QUESTIONS AND CLARIFICATIONS

ADDENDUM 1

project:
**AMITY SCHOOL DISTRICT
DISTRICT OFFICE BUILDING
503 OAK AVENUE
AMITY, OR 97101**

**GRADING &
DRAINAGE PLAN**

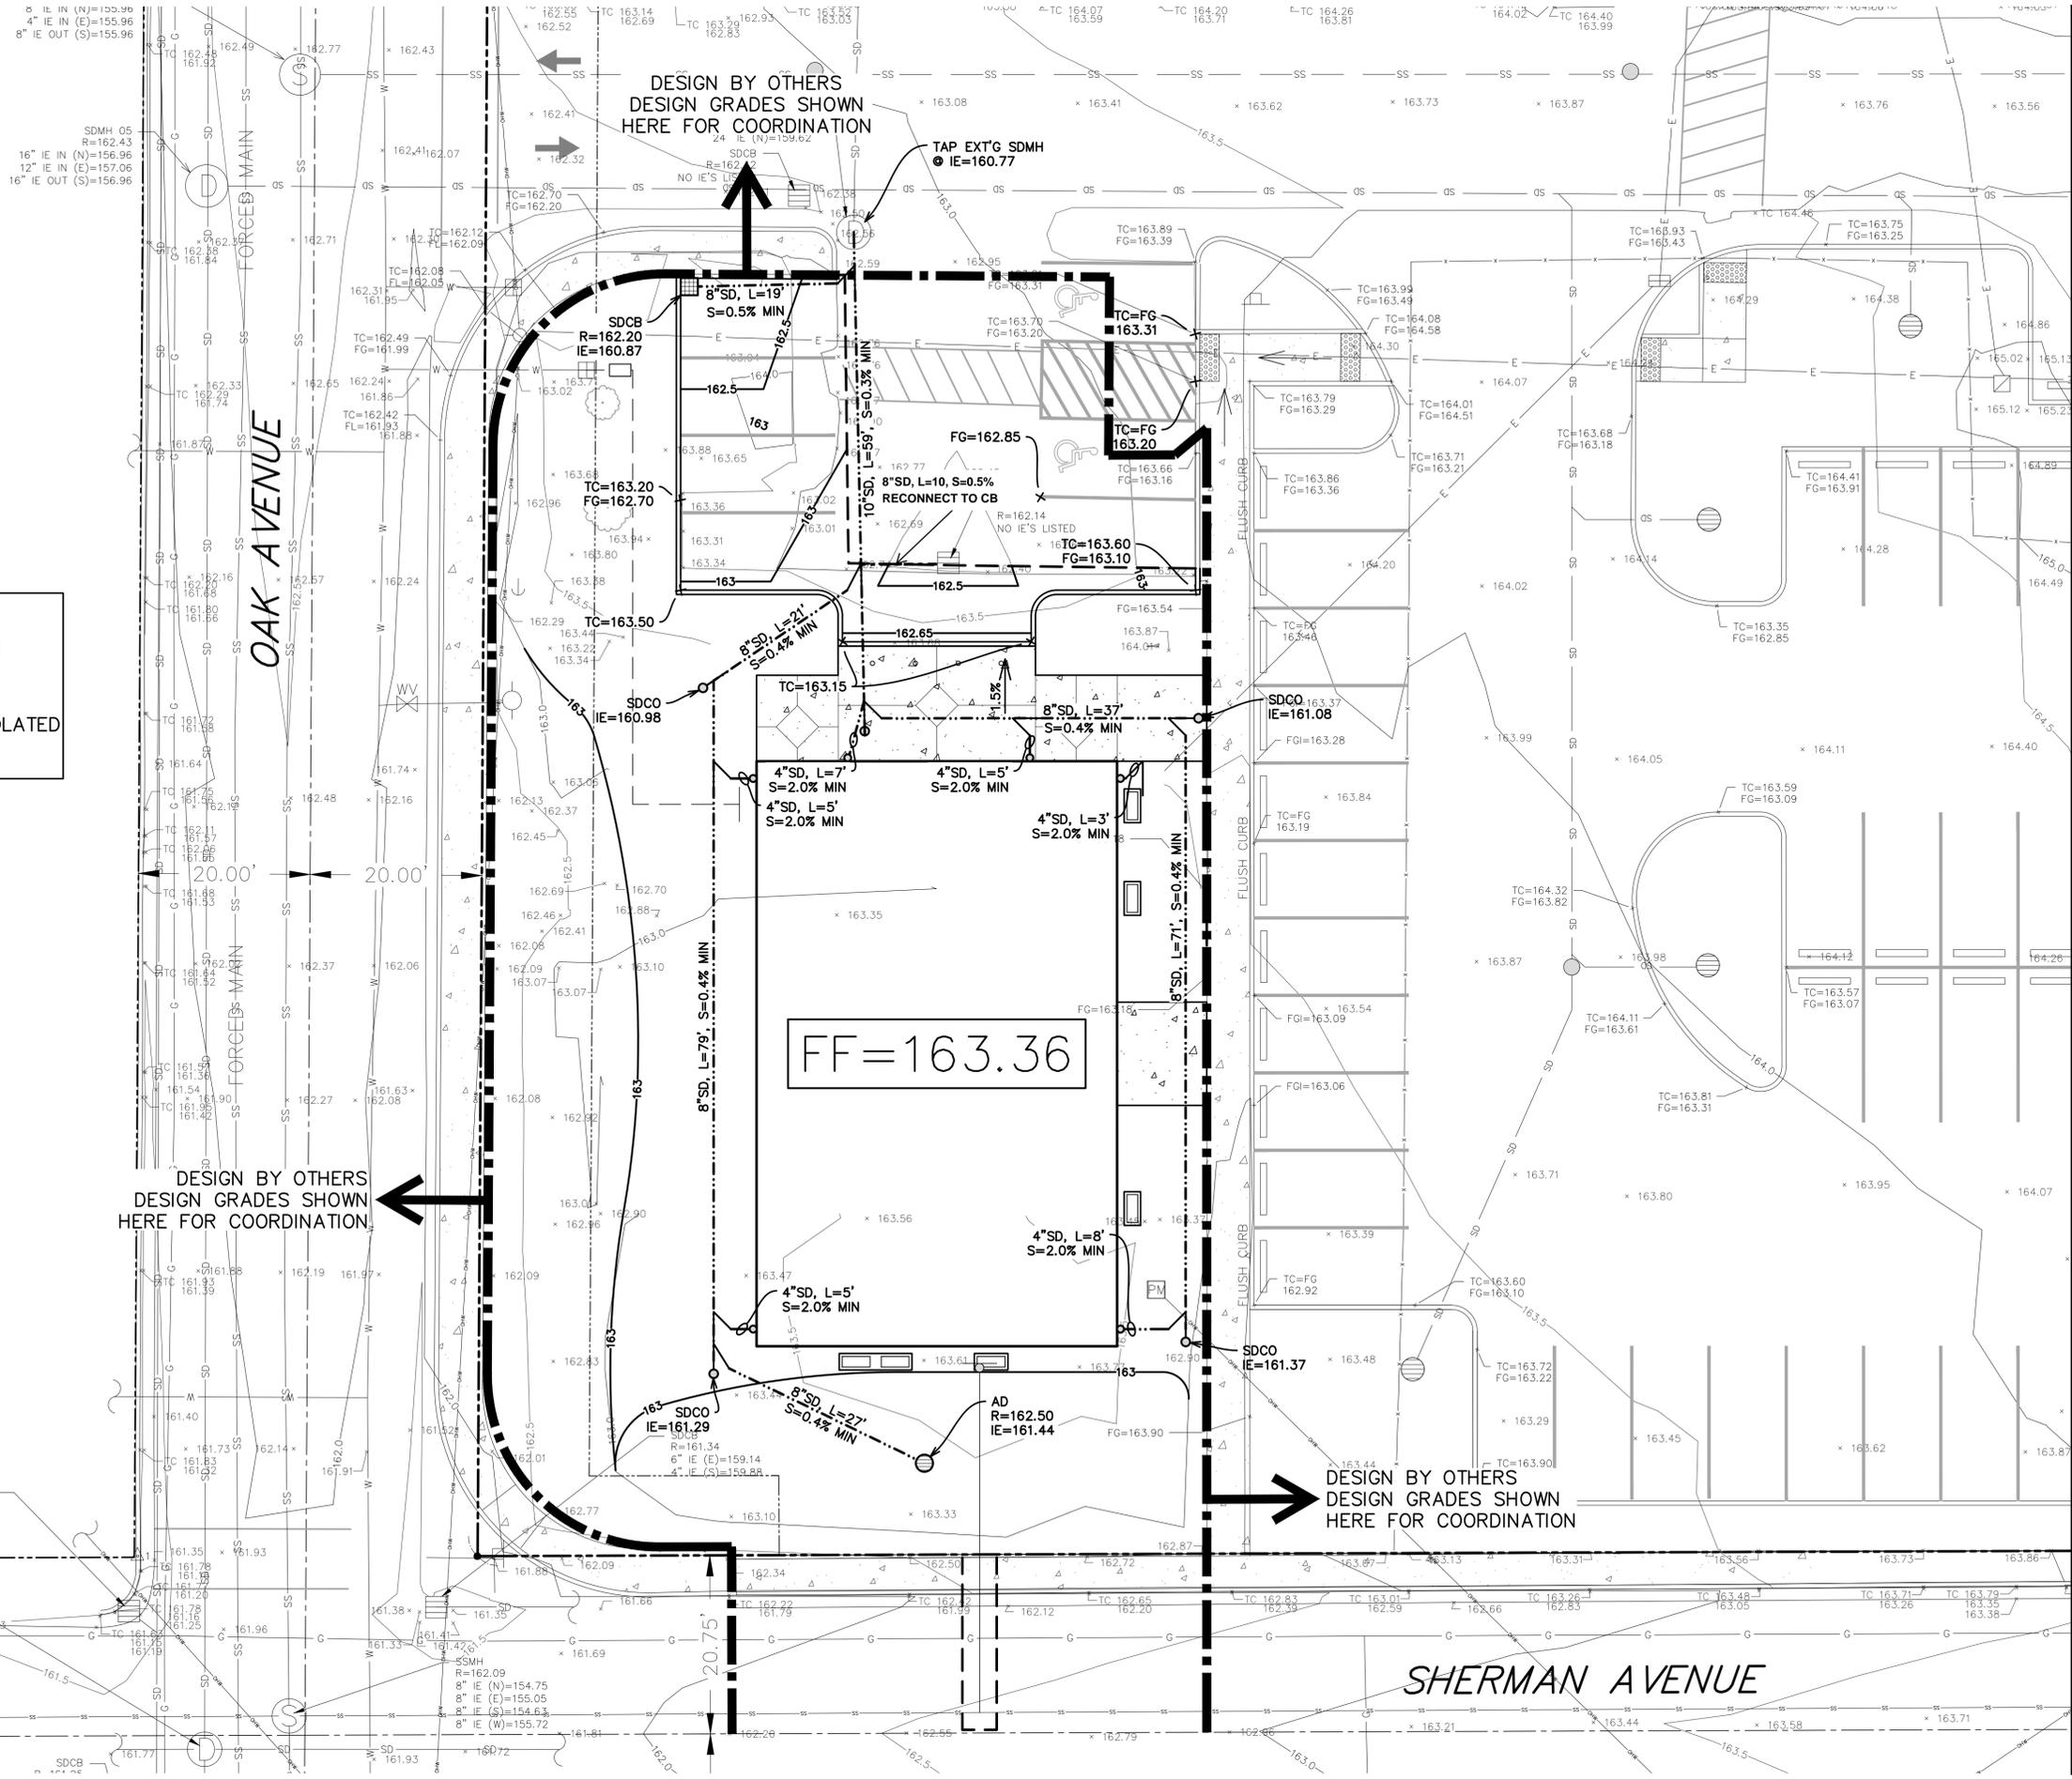
REVISION TO DRAWINGS – C2.0 – GRADING AND DRAINAGE PLAN

Disregard **original** C2.0 Grading and Drainage Plan and replace with **attached C2.0 Grading and Drainage Plan** in its entirety.

UTILITY PLAN

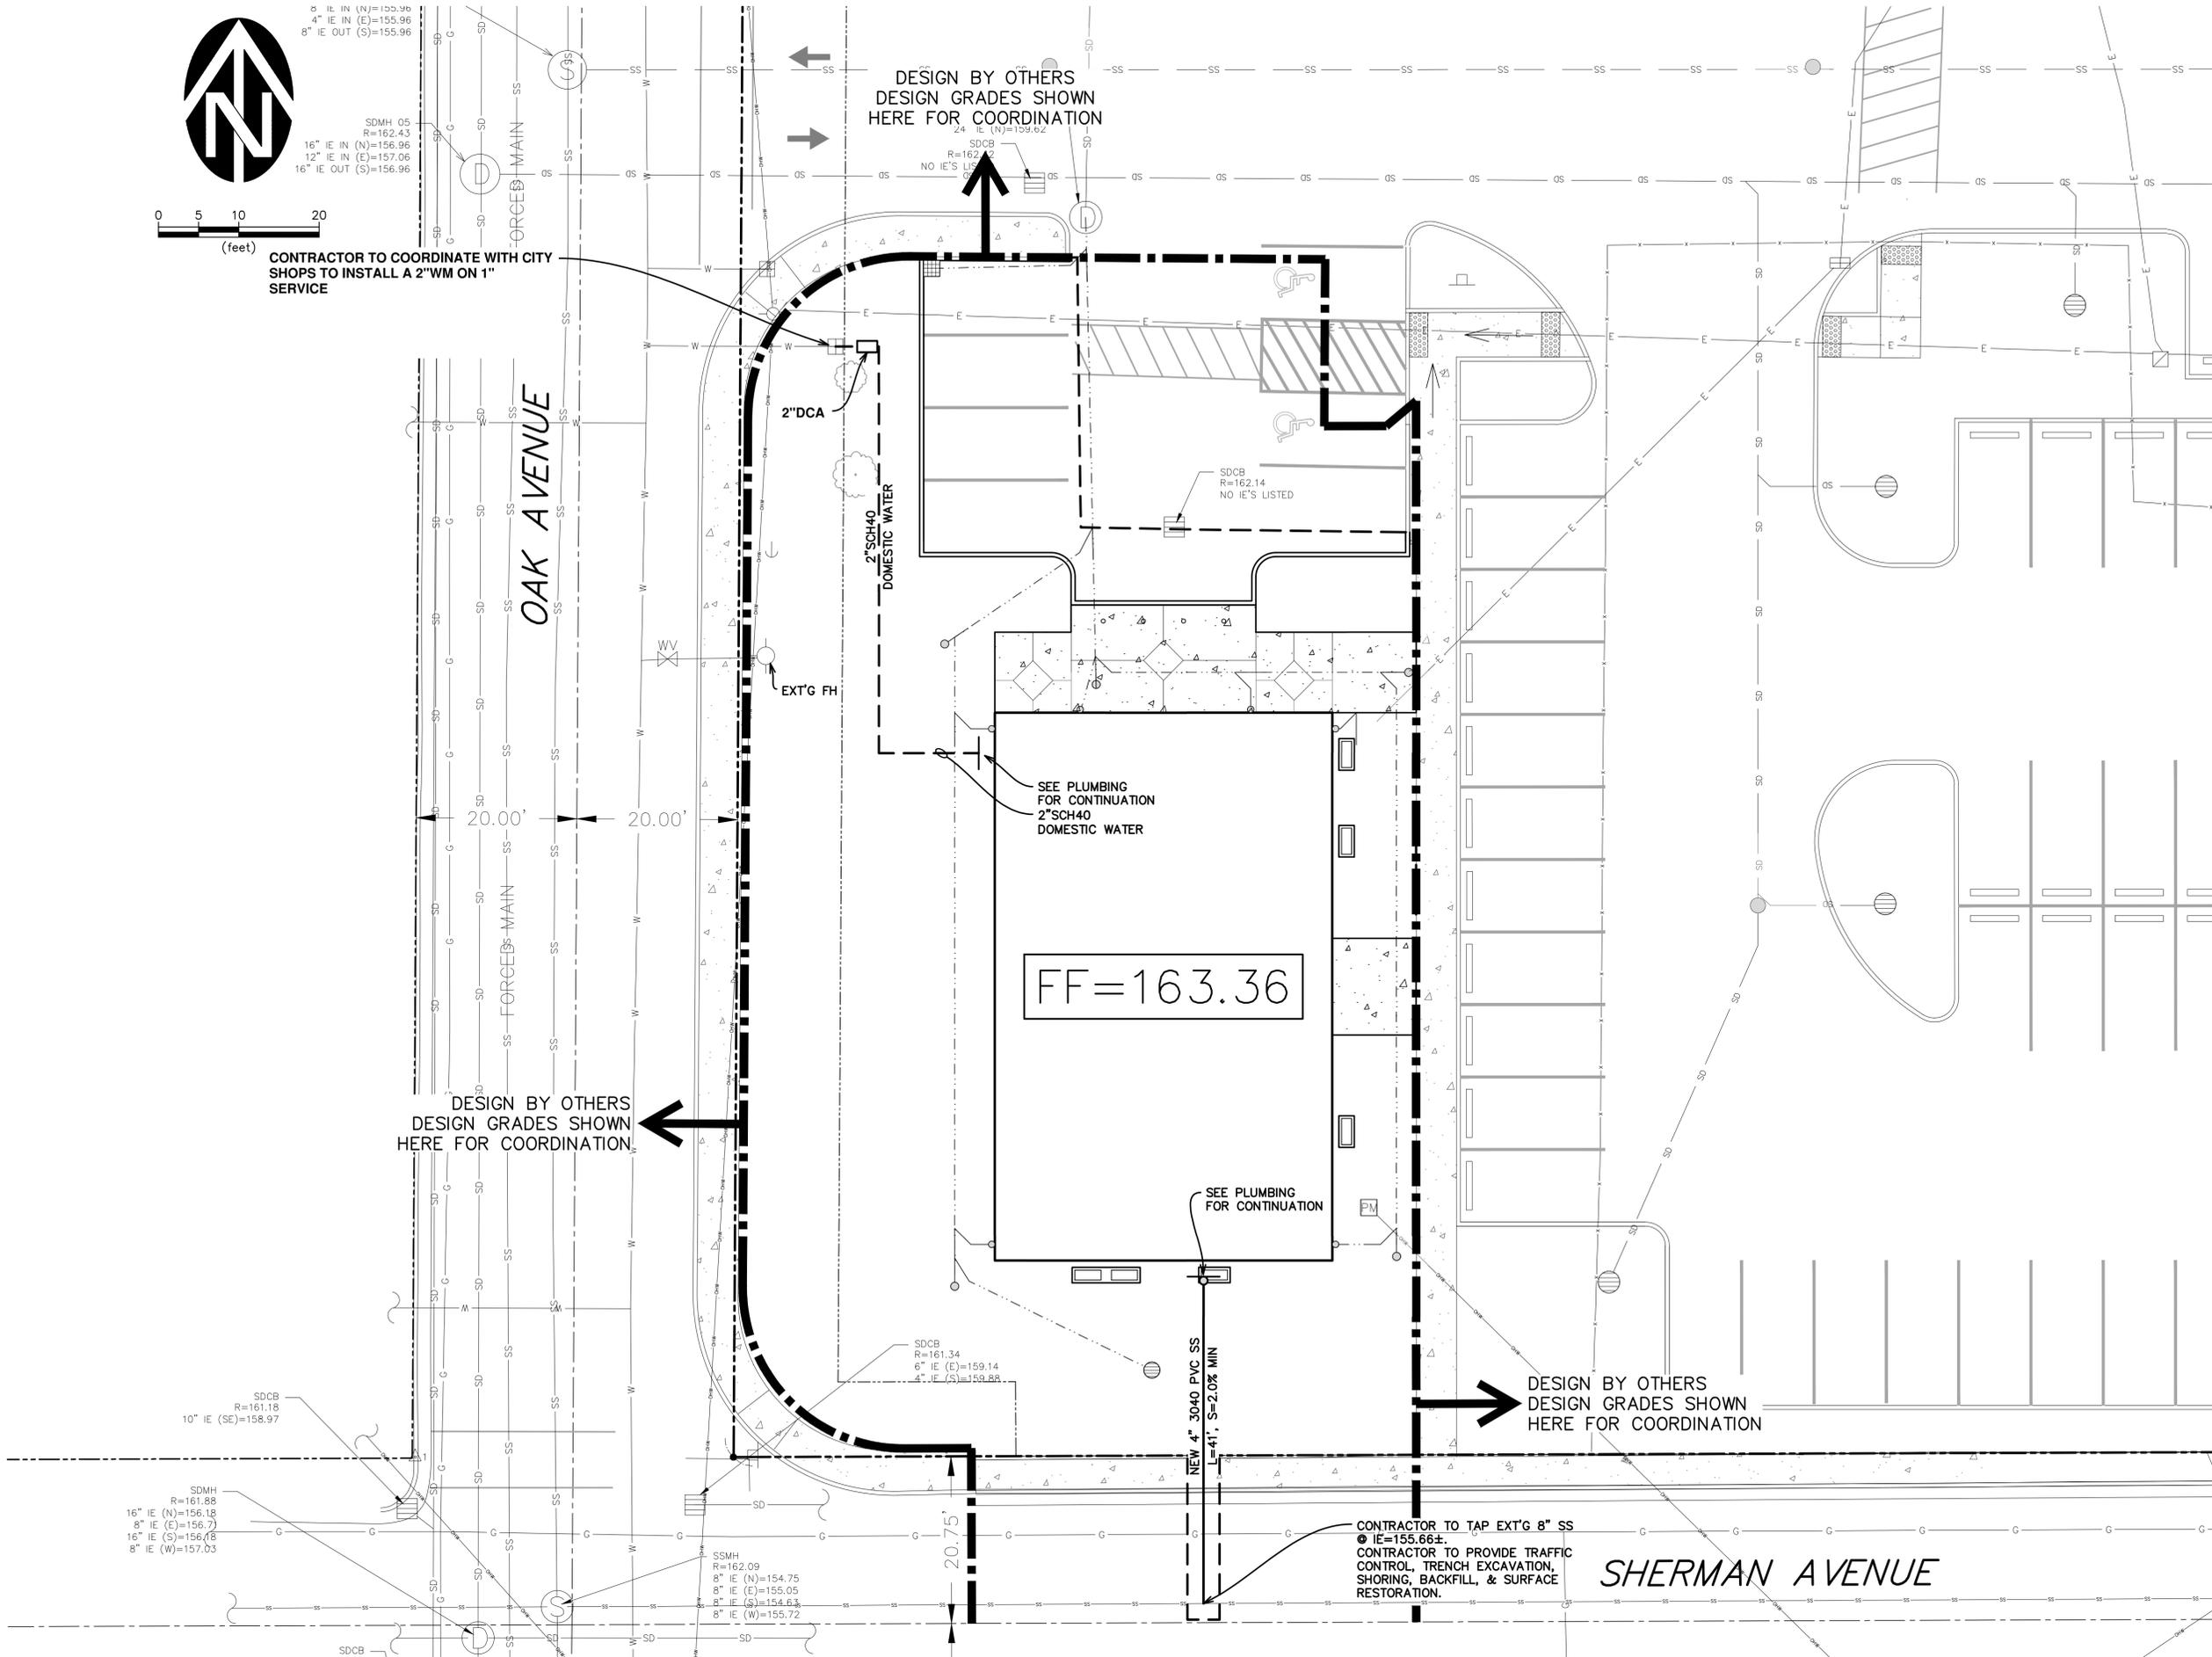
REVISION TO DRAWINGS – C3.0 – UTILITY PLAN

Disregard **original** C3.0 Utility Plan and replace with **attached C3.0 Utility Plan** in its entirety.
